Date: 16/09/2013 Document: **EN 16062**

Based on w15-0428- 121018 HeERO Comment Resolution EN 16062 - ERTICO - v1 0with add. T4 CR and CR#

Annex C.1:

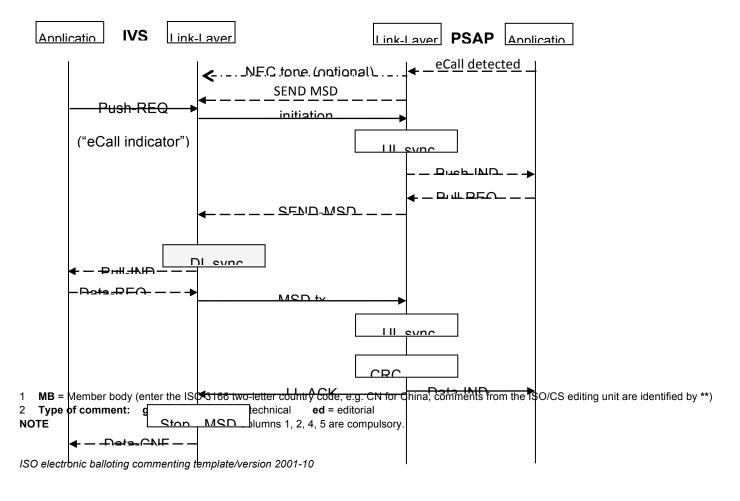
10	7.4.1	Figure 6	ed	See above. Add a clarification concerning the relationship between the EN 16062 SEND-MSD and the TS 126 267 START	Add a note under the figure 6 Note: the SEND-MSD message in this document corresponds to the START message in ETSI TS 126 267.	Editorial clarification
11	7.4.1	Figure 6	te	If the PSAP knows that the incoming call is an eCall, because the eCall indicator has been implemented and used, then the PSAP modem can immediately send the 'SEND MSD' message to the IVS without waiting for the 'INITIATION' message. Waiting for the initiation signal from the IVS adds 2 seconds to the MSD transmission time and increases the amount of time that the PSAP operator and motorist are prevented from engaging in a voice conversation. Reducing the "voice blocking time"	Add the Pull mode procedures in EN 16062 in figure 6: See Annex C.1 below	Technical change. Revision required
